DESCRIPTIVE REPORT

Registery No. H-10178

General Locality Penobscot Bay

Sublocality Fox Islands Thorofare

Danger to Navigation, Uncharted Shoal, Southern Harbor, Fox Islands Thorofare, Maine

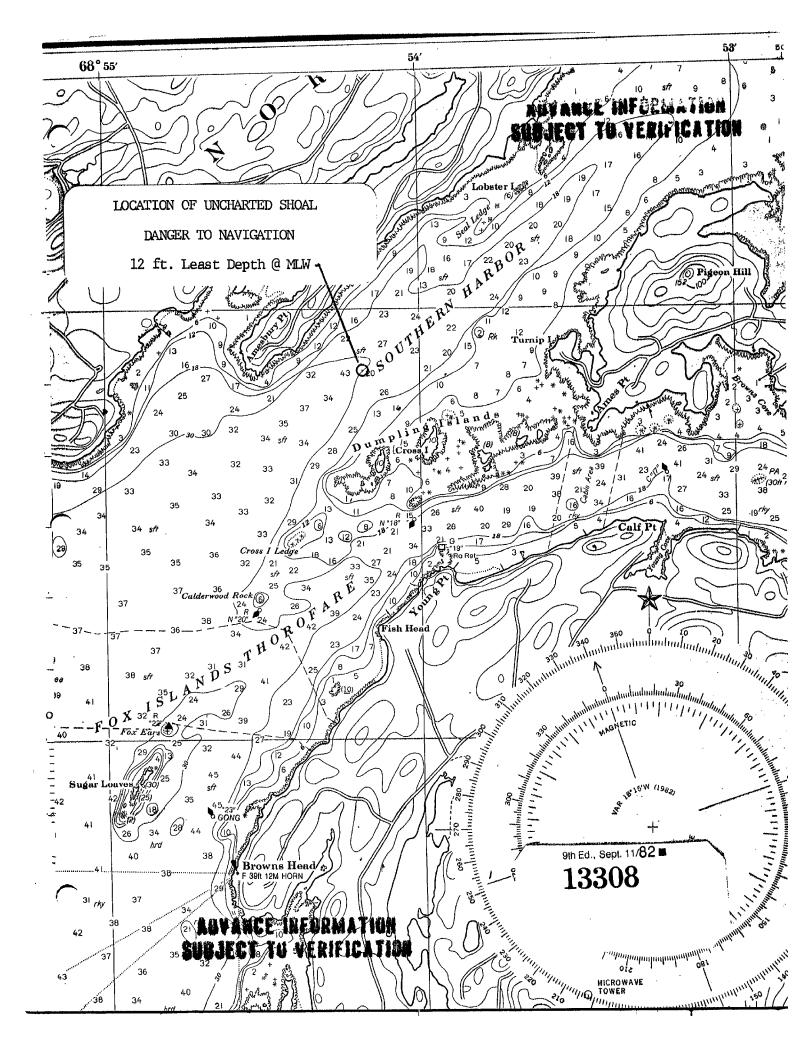
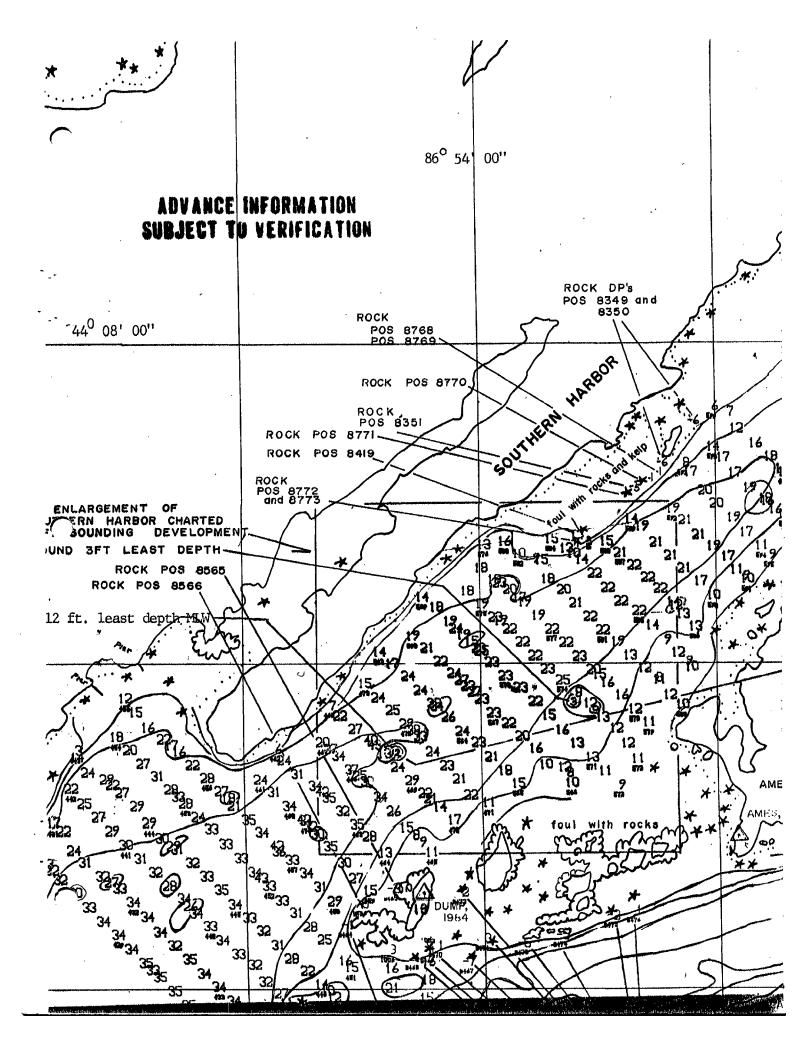
An uncharted shoal in Southern Harbor at latitude 44°07'51.7", longitude 68°54'11.0" exists with a least depth of 12 feet. Charted depths in this vincinity range from 20 to 27 feet.

All depths were recorded on this feature with a Raython 719-B Survey Fathometer. The sounding vessel was positioned by range/azimuth methods using a Hewlett Packard - medium range total station - model 3810B. The least depth given is corrected for predicted tides and is subject to the application of final verified smooth tides.

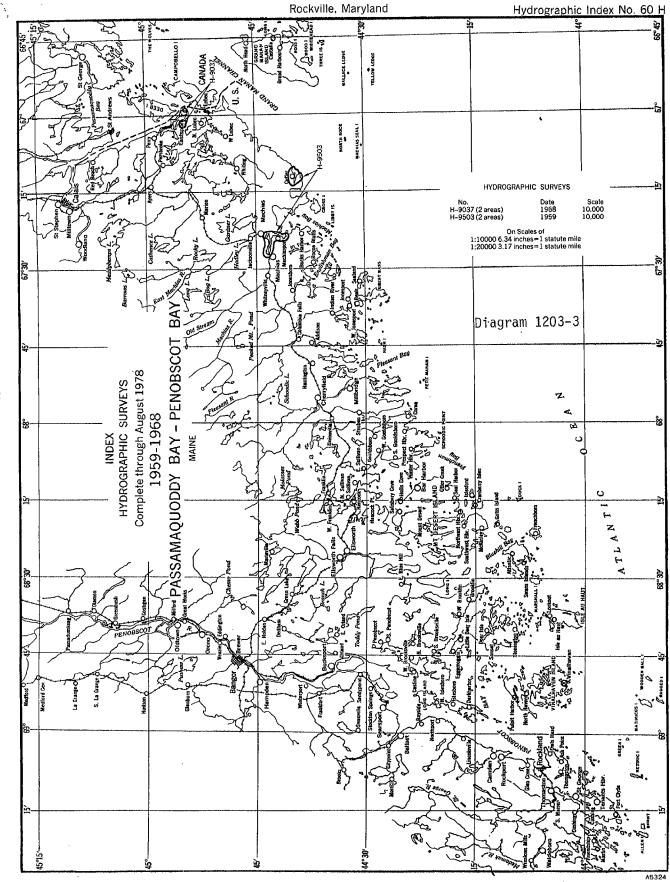
In addition, it is recommended that the hydrography from H-982 between "Sugar Loaves" and "Fox Dars" be considered when applying H-10178 to chart 13308. The 4- and 8-foot soundings on the shelf extending off the northern end of "Sugar Loaves" should also be reconsidered for charting since the present survey did not develop this area and indicates a depth of 12 feet in the vicinity.

A 50-percent reduction of chart 13308 (9th edition) is attached with soundings brought forward from prior surveys circled. These soundings were neither verified nor disproved by H-10178. This copy is meant merely to aid in the application of the present survey by emphasizing various discrepancies and should not be considered an official source document.
